Harold Frank Hall HVAC Upgrade Floors 1-5  
Project No. FM070432L/211-09  
**Addendum No. 2**

ADDENDUM NUMBER 2  
to the  
CONSTRUCTION DOCUMENTS  
October 9, 2007

SK-01

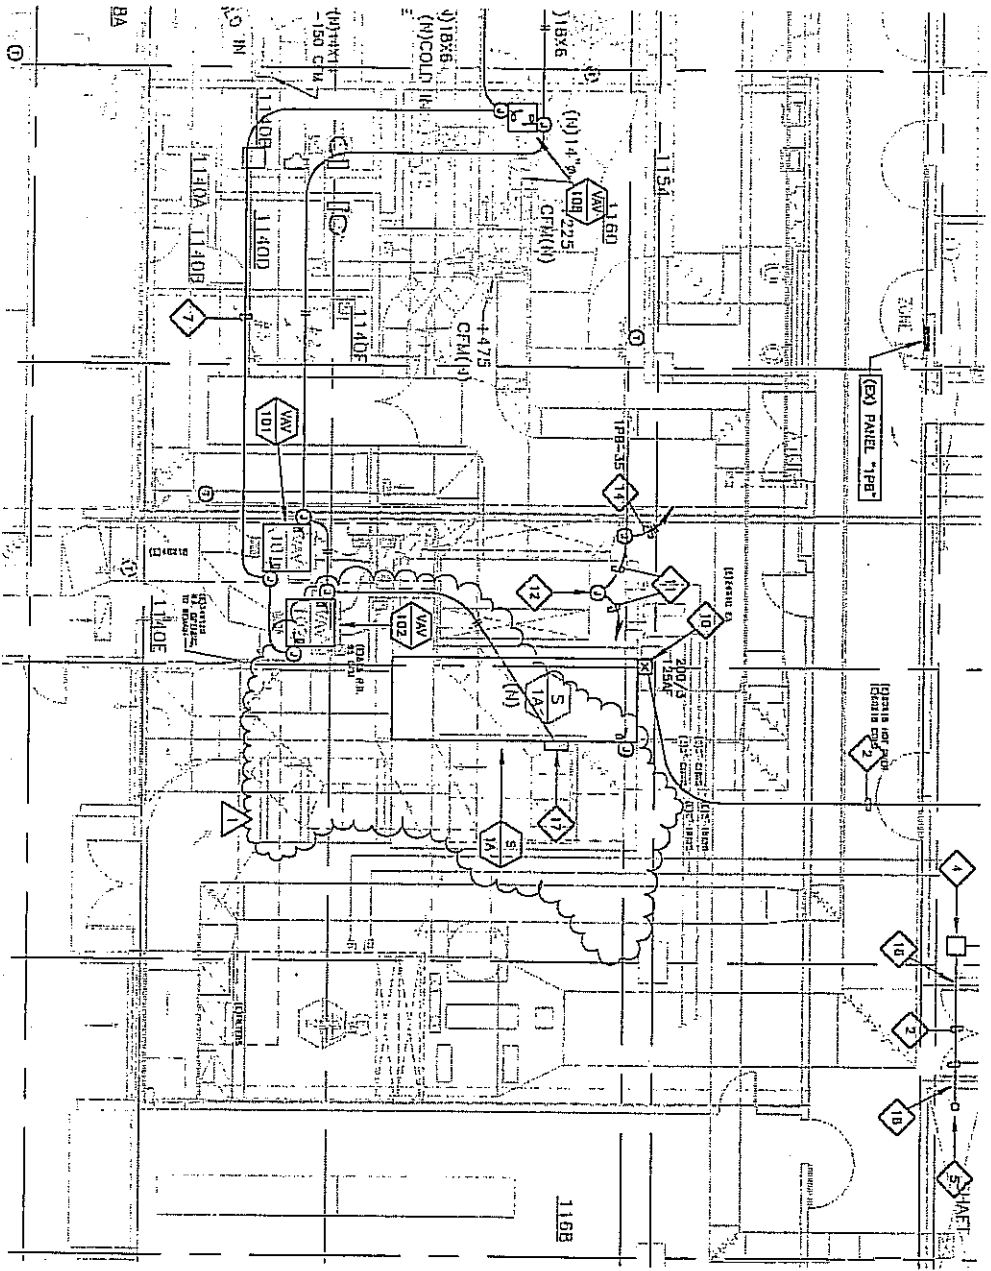
12. SHEET M5.0 – “MECHANICAL DETAILS AND ELEVATIONS”; **Replace** with attached revised drawing M5.0 revised date 9/27/07.
13. SHEET E1.0 – “SYMBOLS, SINGLE LINE DIAGRAM AND PANEL SCHEDULES”; **Revise** “(N) Panel 6A” with sketch SK-01 “panel schedule 6A” dated 10/2/07.

SK-02

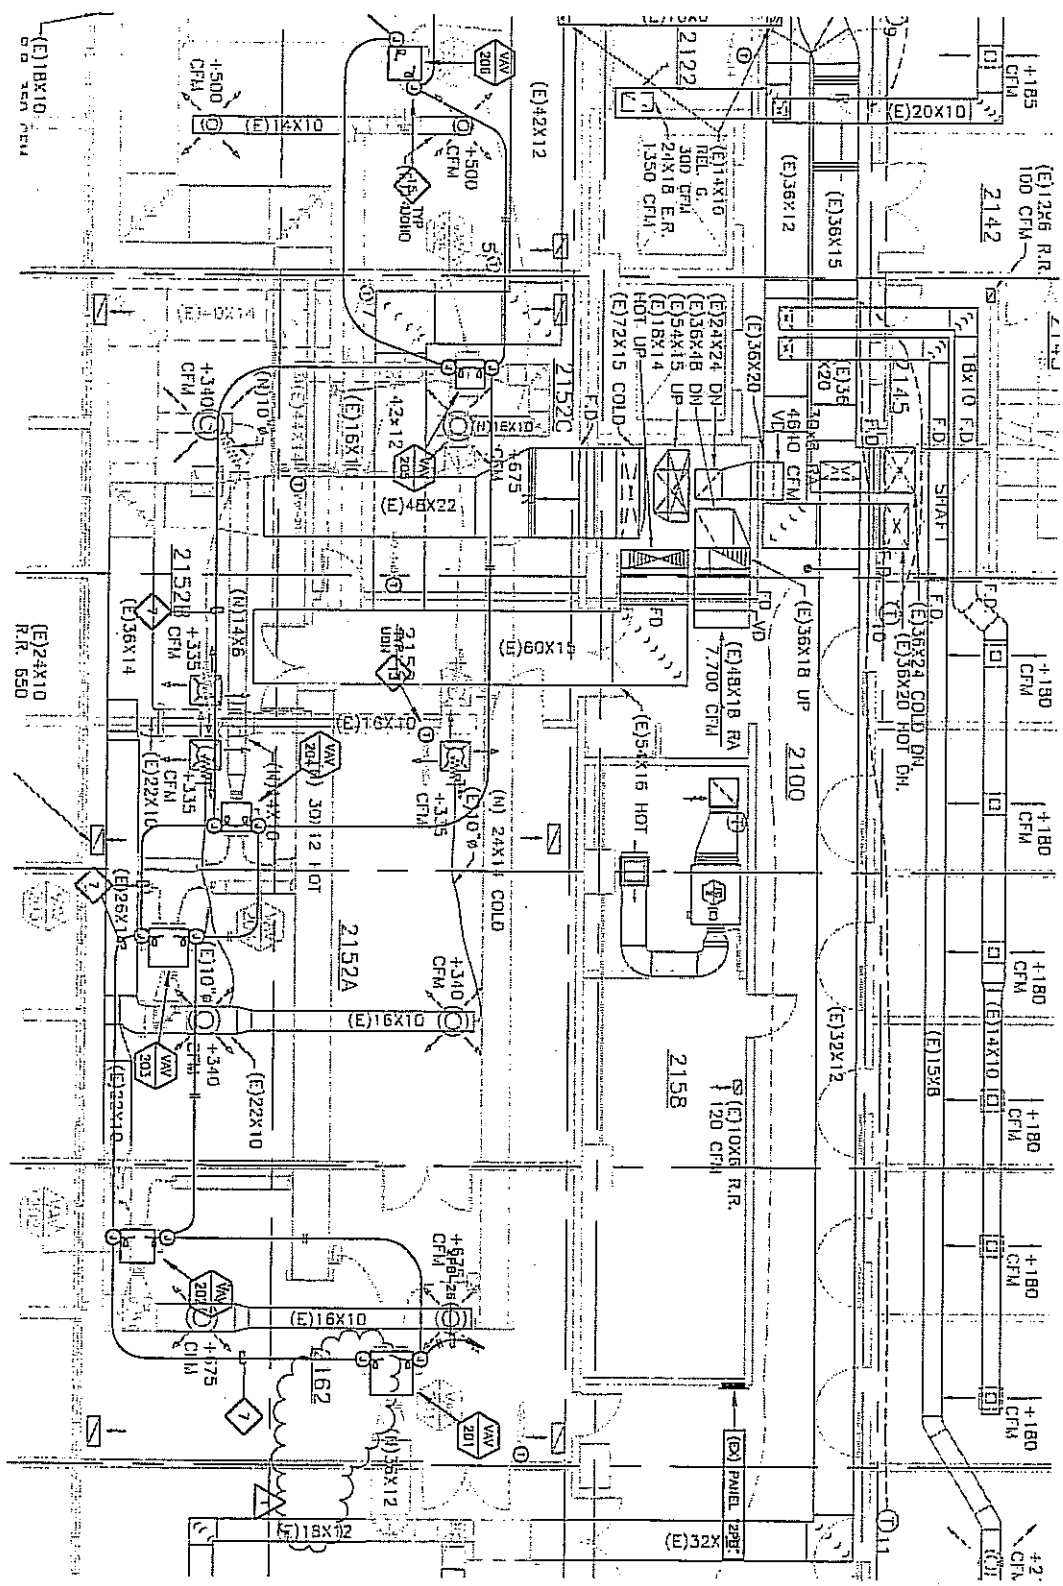
14. SHEET E2.1 – “FIRST FLOOR POWER AND SIGNAL PLAN”; **Revise** electrical key notes to add note #17 see attached sketch SK-02 “partial first floor power and signal plan” dated 10/20/07.

15. SHEET E2.1 – “FIRST FLOOR POWER AND SIGNAL PLAN”; **Revise** electrical key notes to add note #18 see attached sketch SK-02 “partial first floor power and signal plan” dated 10/20/07.

- ELECTRICAL KEY NOTES**  
(NOTE: ALL NOTES MAY NOT APPEAR ON THIS SHEET)
- 17 PREPARE 120V CONNECTION TO DR-8170 CONTROLLER, SEE ORDER OF CONTRACT, SYSTEM THROUGH. LOCATION WITH CONTROL SYSTEM THROUGH.
  - 18 CONNECT 120V POWER TO (N) SMOKE/FIRE DAMPER, ROUTE POWER THROUGH CONTACT IN SMOKE DETECTION TO CLOSE DAMPER ON SMOKE ALARM.

PARTIAL SECOND FLOOR POWER AND SIGNAL PLAN

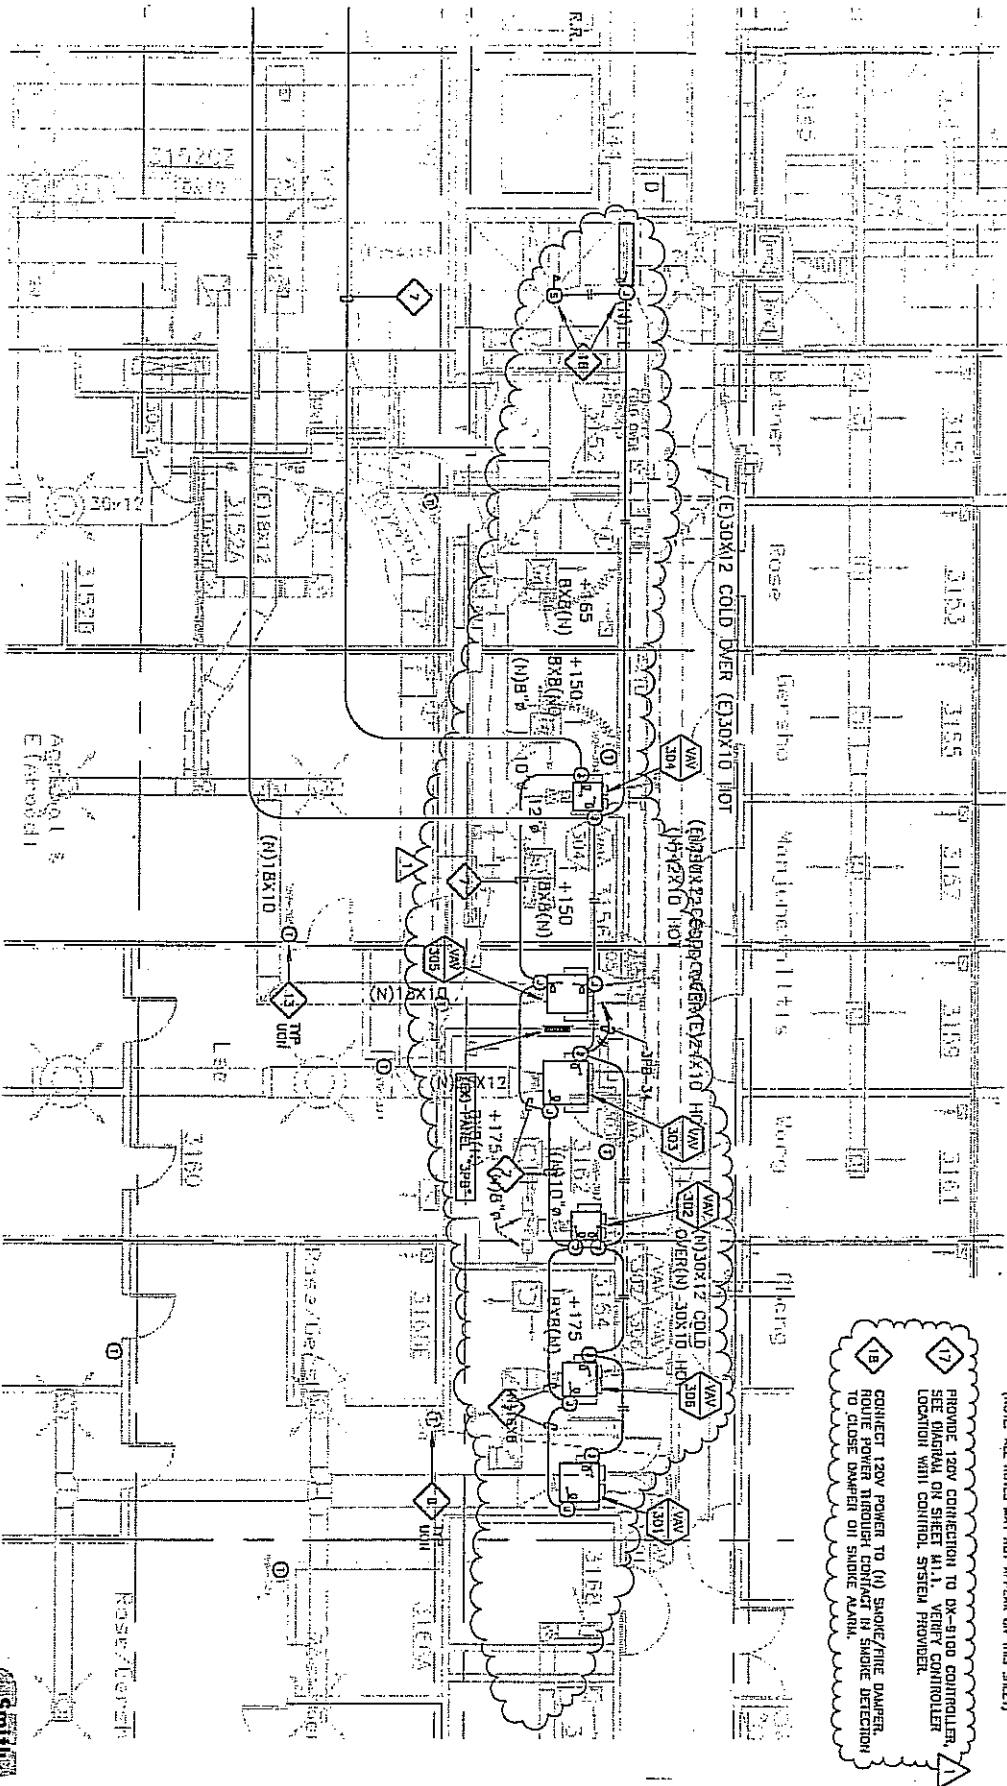
16. SHEET E2.2 – “SECOND FLOOR POWER AND SIGNAL PLAN”; **Revise** additional electrical work see attached sketch SK-03 “partial second floor power and signal plan” dated 10/2/07.

SK-04

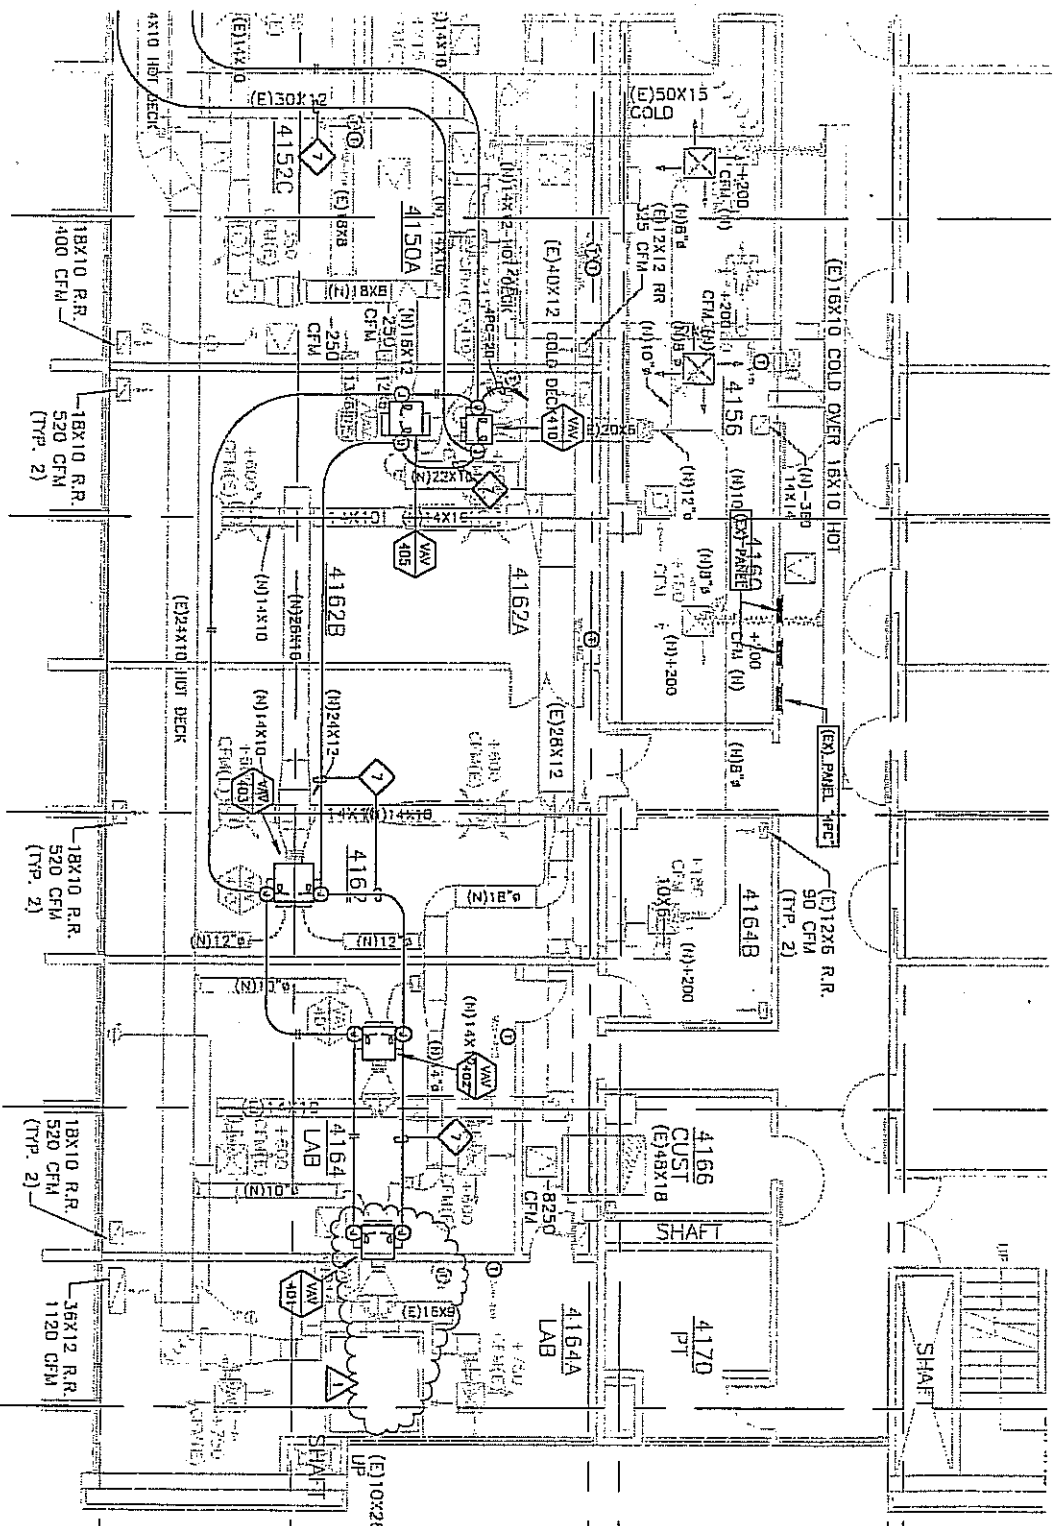
17. SHEET E2.3 – “THIRD FLOOR POWER AND SIGNAL PLAN”; **Revise** electrical key notes to add note #17 see attached sketch SK-04 “partial third floor power and signal plan” dated 10/2/07.

18. SHEET E2.3 – “THIRD FLOOR POWER AND SIGNAL PLAN”; **Revise** electrical key notes to add note #18 see attached sketch SK-04 “partial third floor power and signal plan” dated 10/2/07.

17 PROVIDE 120V CONNECTION TO BX-400 CONTROLLER, SEE DIAGRAM OR SHEET #11 VERIFY CONTROLLER LOCATION WITH CONTROL SYSTEM PROVIDER.

18 CONNECT 120V POWER TO (H) SMOKE/FIRE DAMPER, ROUTE POWER THROUGH CONTACT IN SMOKE DETECTOR TO CLOSE DAMPER ON SMOKE ALARM.

SK-05

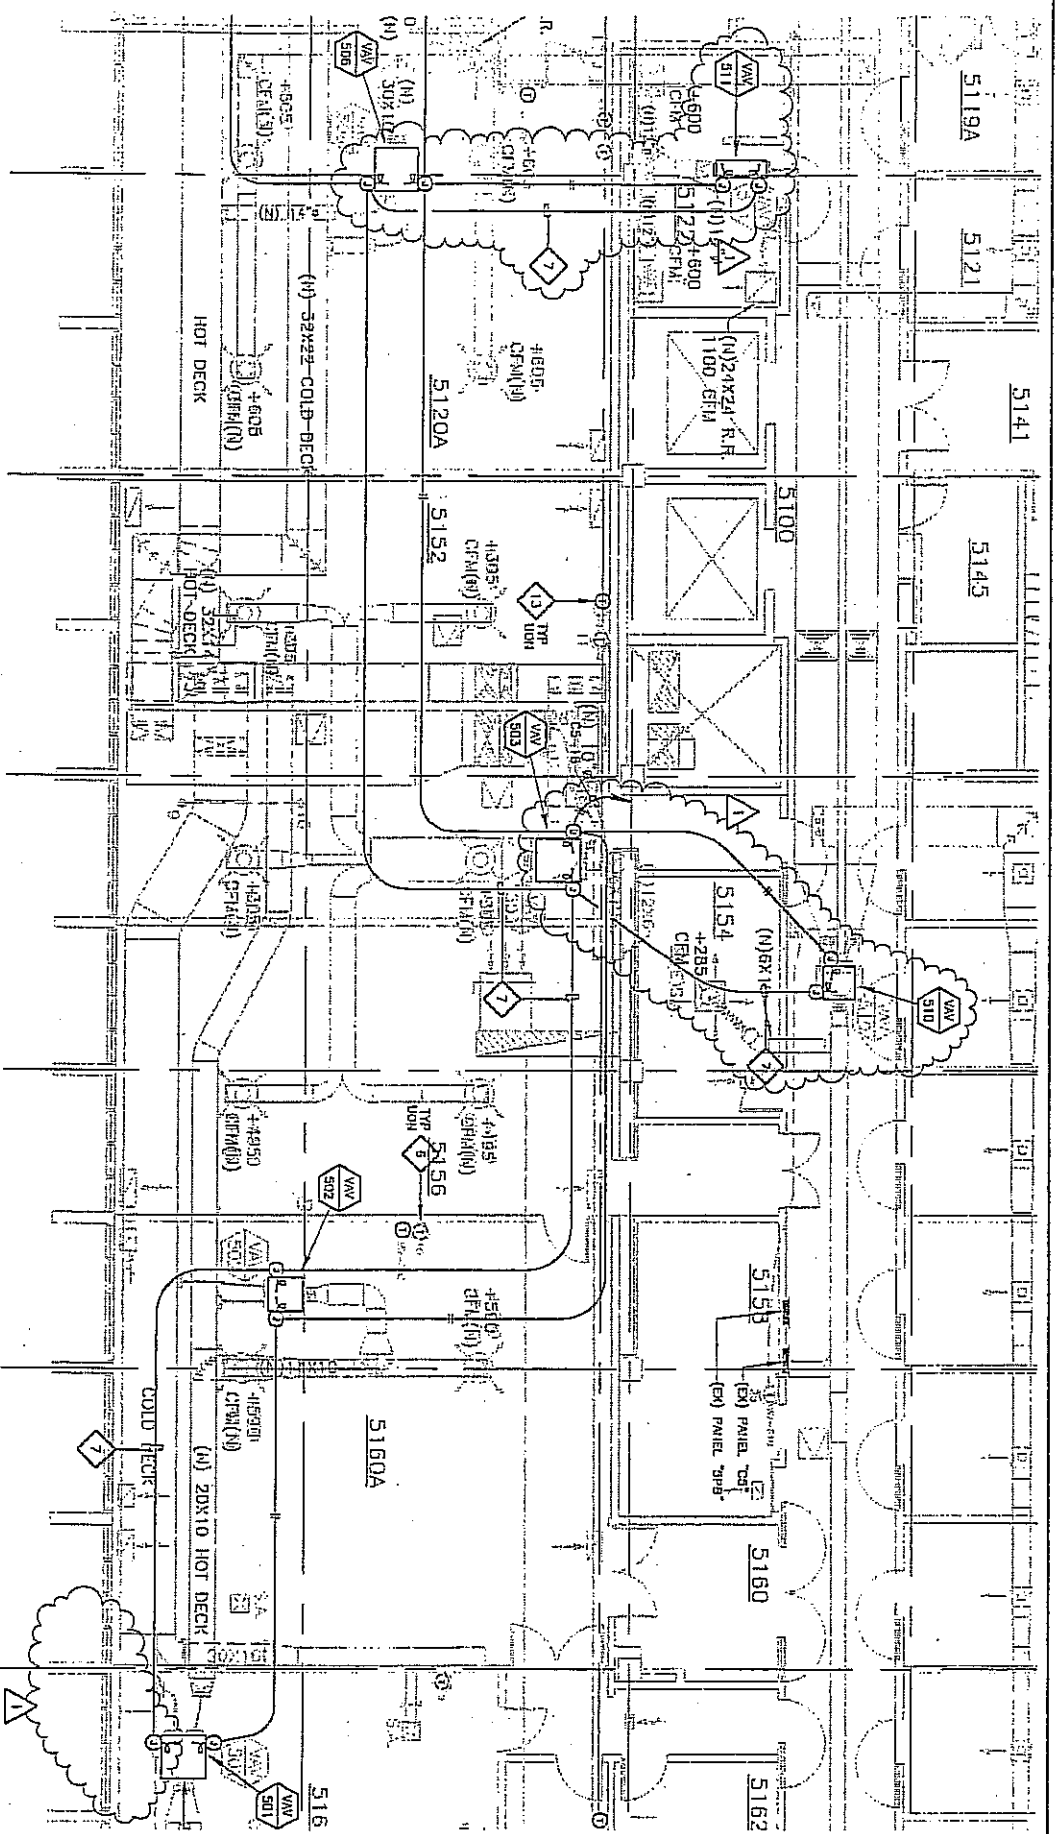
19. SHEET E2.4 – “FOURTH FLOOR POWER AND SIGNAL PLAN”; **Revise** additional electrical work see attached sketch SK-05 “partial fourth floor power and signal plan” dated 10/2/07.

SK-06

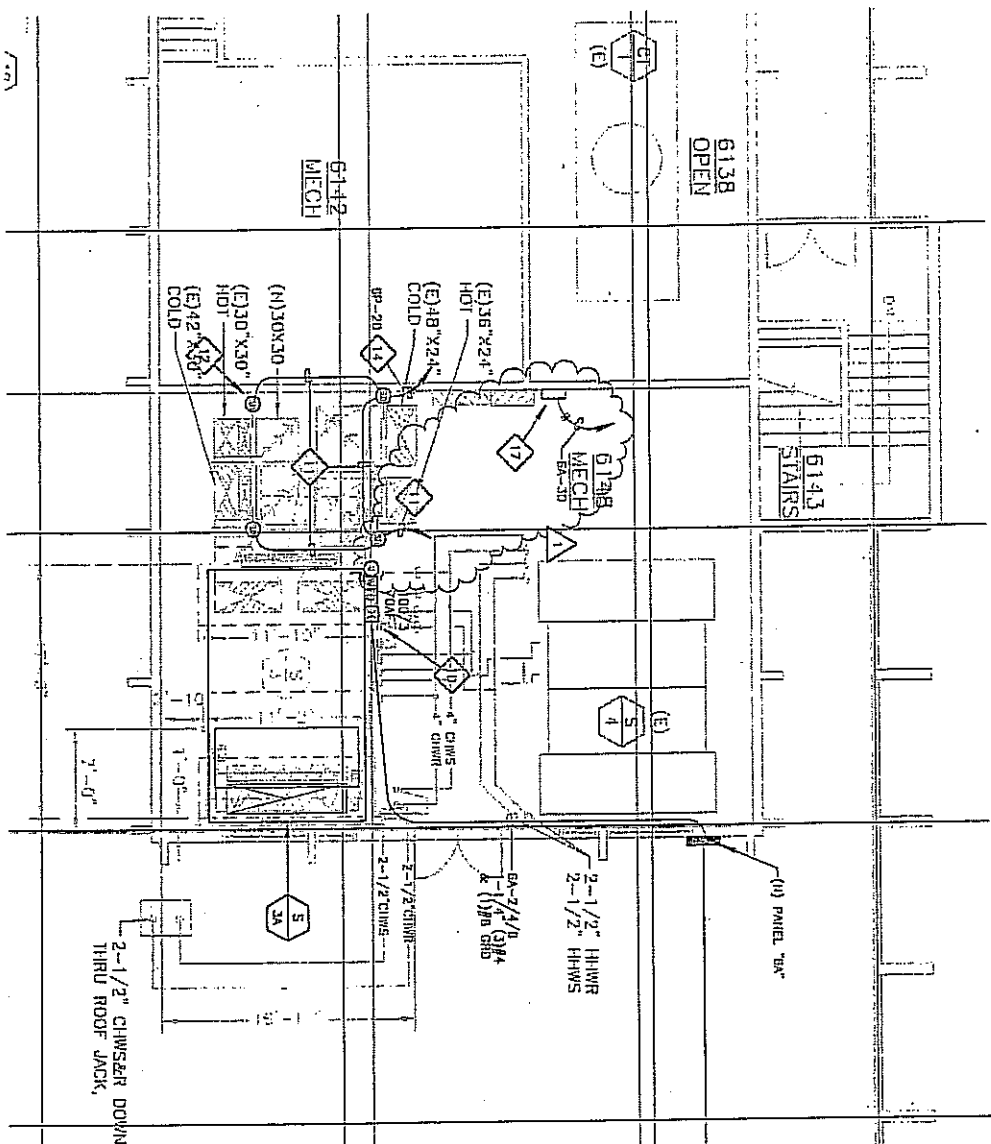
20. SHEET E2.5 – “FIFTH FLOOR POWER AND SIGNAL PLAN”; **Revise** additional electrical work see attached sketch SK-06 “partial fifth floor power and signal plan” dated 10/2/07.
